From: Perry Buckberg
To: Amar Pal; Angelo Stubbs; Billy Rogers; Brian Lee; Christopher Sydnor; David Jeng; Edwin Forrest; Ganesh Cheruvenki; Geoffrey Ottenberg; Greg Galletti; James Davis; James Medoff; Muhammad Razzaque; Naeem IQBAL
Date: 9/13/2006 3:35:34 PM
Subject: Entergy Memo of 9/13/2006 - Pilgrim

SUBJECT: Entergy Nuclear Operations, Inc.
Pilgrim Nuclear Power Station
Docket No. 50-293 License No. DPR-35

This License Renewal Application (LRA) amendment consists of five attachments. Attachment A contains the revised list of regulatory commitments. Attachment B contains the response to requests for additional information (RAIs) on LRA Section 2.4, Scoping and Screening Results: Structures, conveyed in NRC letter dated August 22, 2006. Attachment C contains the response to the RAIs on LRA Sections 3.5, Structures and Component Supports, and 3.6, Electrical and Instrumentation and Control Systems, conveyed in NRC letter dated August 14, 2006. Attachment D contains changes to the LRA. Attachment E contains the database of questions and answers from NRC audits of the LRA Aging Management Programs and Aging Management Reviews.

Response to Requests for Additional Information (RAI

The simplified drawings on the following two pages depict the Pilgrim refueling cavity seal components.

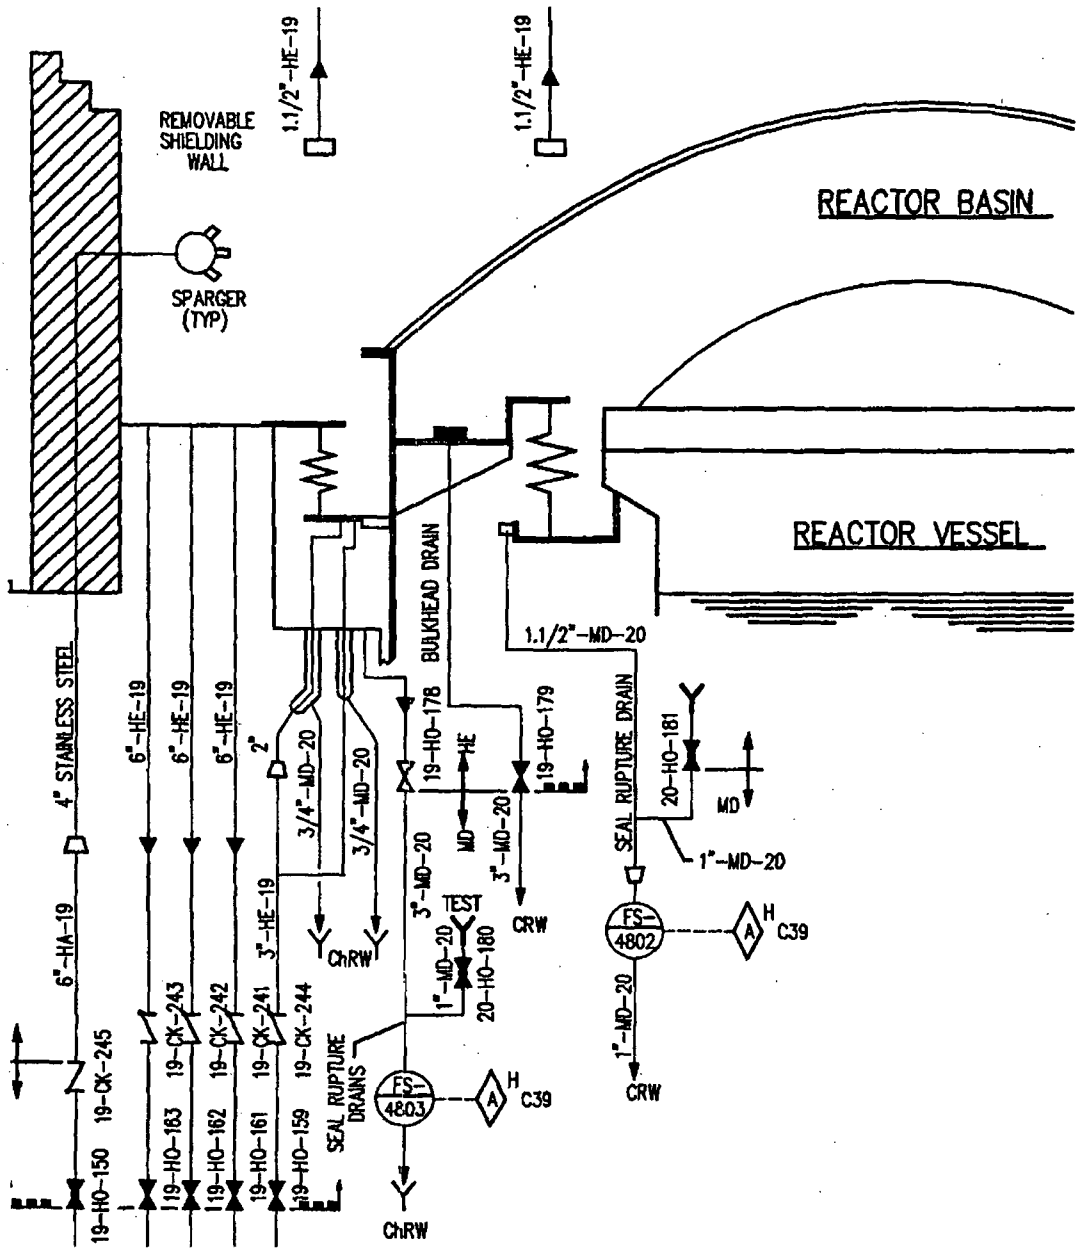
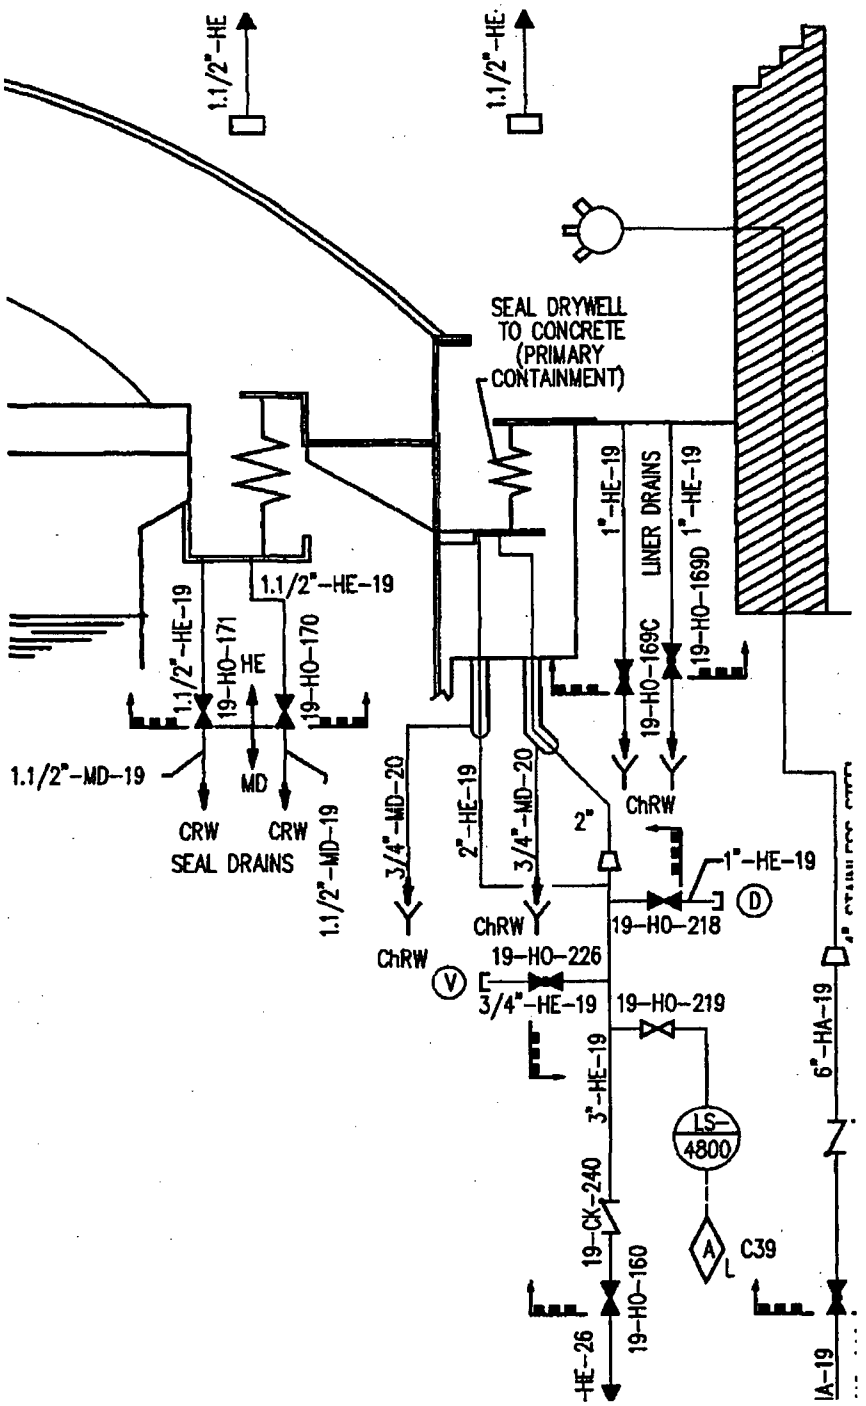
Neither Table 2.4-1, Primary Containment, nor Table 2.4-2, Reactor Building, of the LRA incorporates refueling cavity seal components within the scope of license renewal. The proposed license renewal interim staff guidance LR-ISG-2006-01, "Plant Specific Aging Management Program for Inaccessible Areas of Boiling Water Reactor Mark 1 Steel Containment Drywell Shell," which was published in the Federal Register on May 9, 2006, stated that the most likely cause of corrosion of the drywell shell in the sand-pocket areas (near the bottom of the drywell), and in the spherical portion of the drywell at higher elevations, was the water in the gap between the drywell and the concrete shield, and the source of the water was noted as leakage through the seal between the drywell and the refueling cavity. Therefore, the staff requests the applicant include all the refueling cavity seal components within the scope of license renewal and provide a drawing that depicts the refueling cavity seal components.

Proposed license renewal interim staff guidance LR-ISG-2006-01, "Plant Specific Aging Management Program for Inaccessible Areas of Boiling Water Reactor Mark 1 Steel Containment Drywell Shell," which was published in the Federal Register on May 9, 2006, states, if moisture has been detected or suspected in the inaccessible area on the exterior of the drywell shell, include in the scope of license renewal any components that are identified as a source of moisture, such as the refueling seal, and perform an aging management review. As stated in Amendment 1 to the PNPS LRA[1], there has been no observed leakage causing moisture in the vicinity of the sand cushion at PNPS and no moisture has been detected or is suspected on the inaccessible areas of the drywell shell. Therefore, consistent with the draft ISG, the refueling seal is not subject to aging management review. In response to staff questions during the site audit, PNPS confirmed that refueling cavity seal components do not perform a license renewal intended function and are not subject to aging management review.
